RESOLUTION NO. 639

A RESOLUTION OF THE CITY OF REDMOND, WASHINGTON, APPROVING A REQUEST FOR MODIFICATION OF THE OVERLAKE SQUARE PHASE II BINDING SITE PLAN

CONDITIONS OF APPROVAL - OVERLAKE EAST SITE PLAN SPR-83-1I. Utilities

OVERLAKE EAST
ELEVATIONS

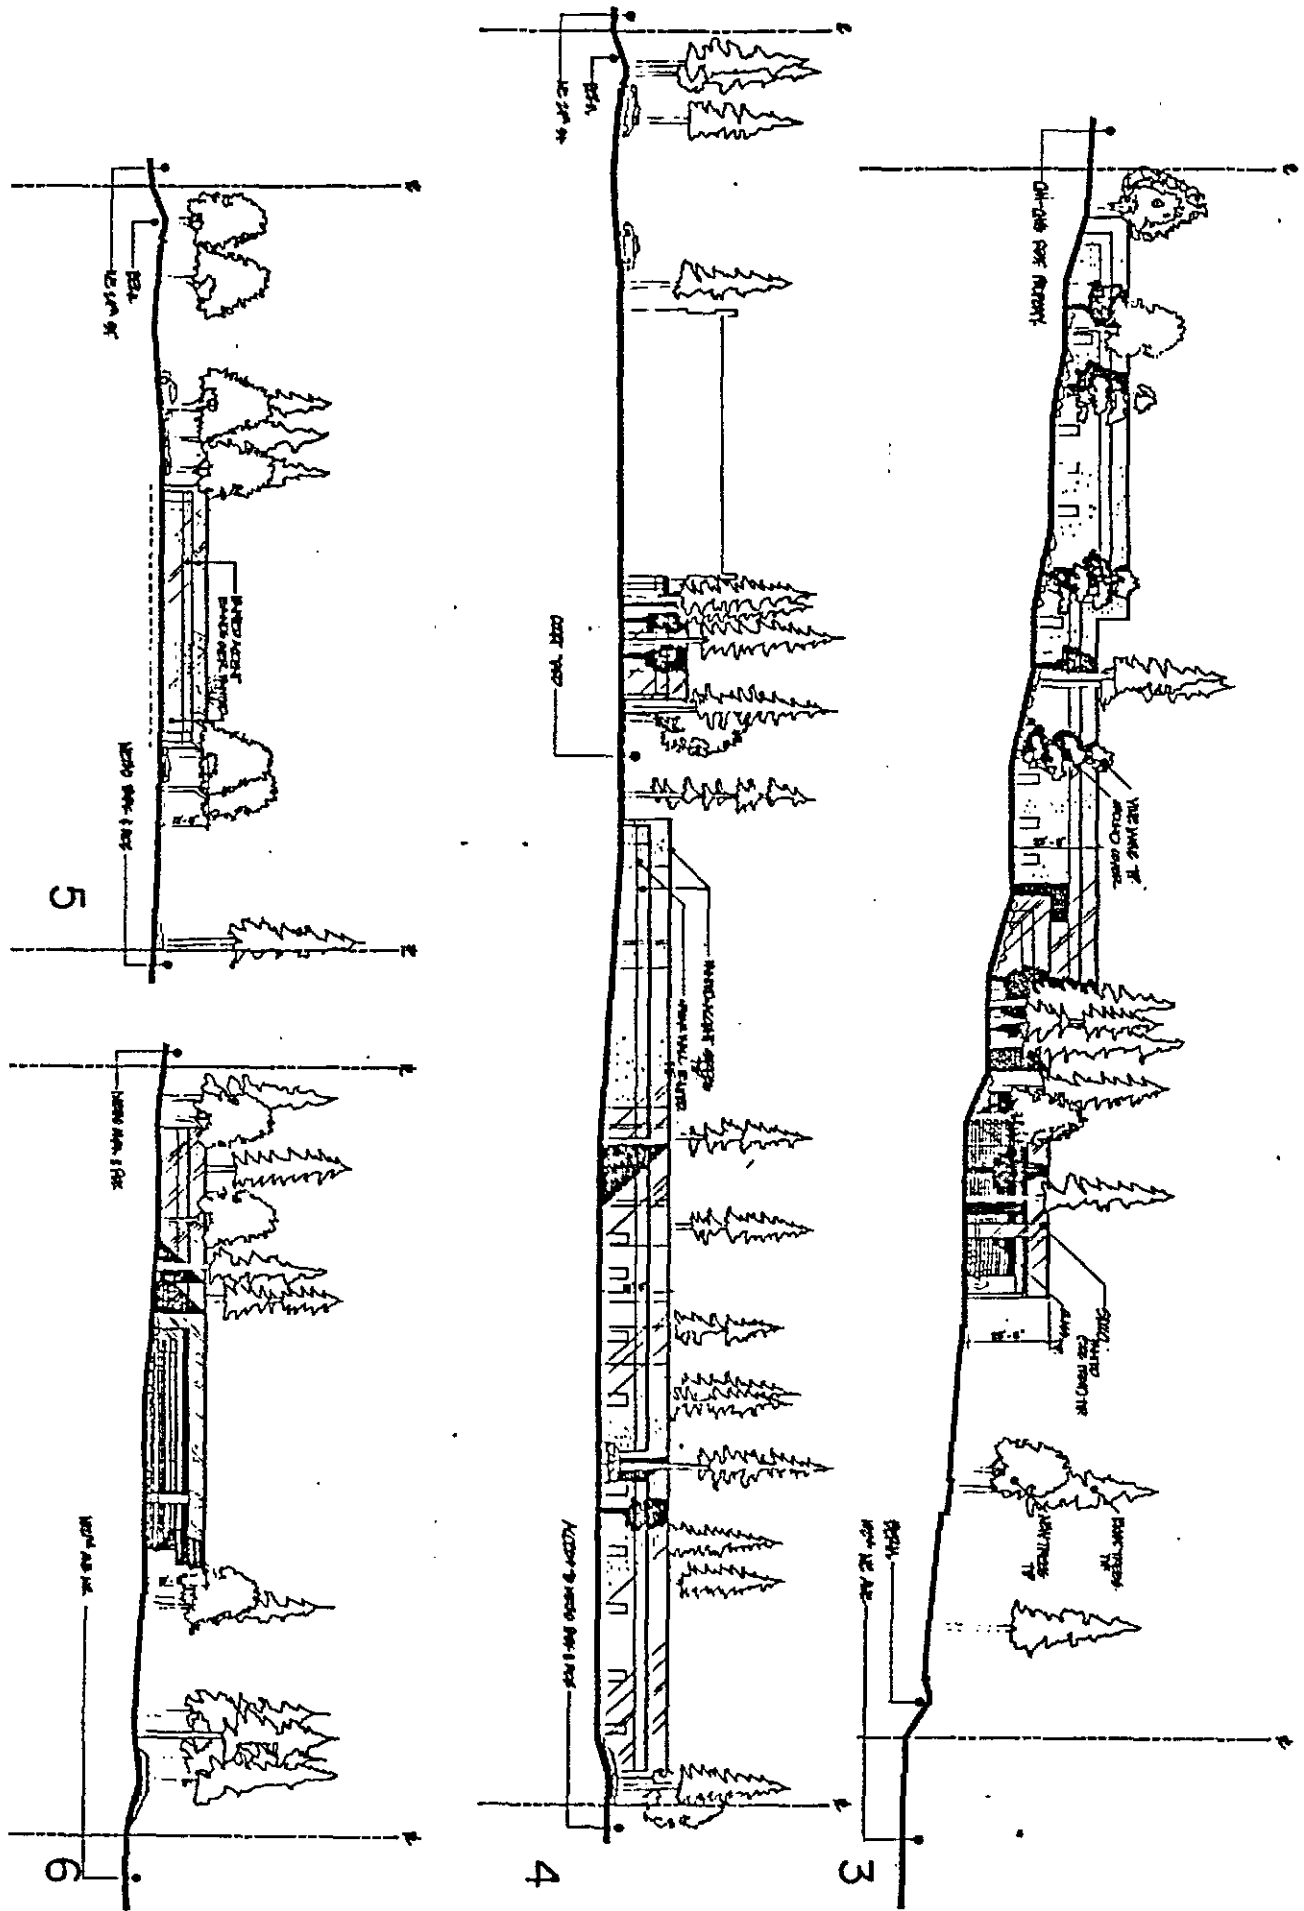
- A. Request a treatment be considered to break up the large glass areas of the window walls, which should emphasize the long horizontal lines of the buildings and carry across an accent color. Final design of the treatment shall be approved by the Design Review Board.
- B. A sign program for all tenant signs shall be submitted for approval by the Design Review Board. Individual letter wall signs are required for the sign fascia.
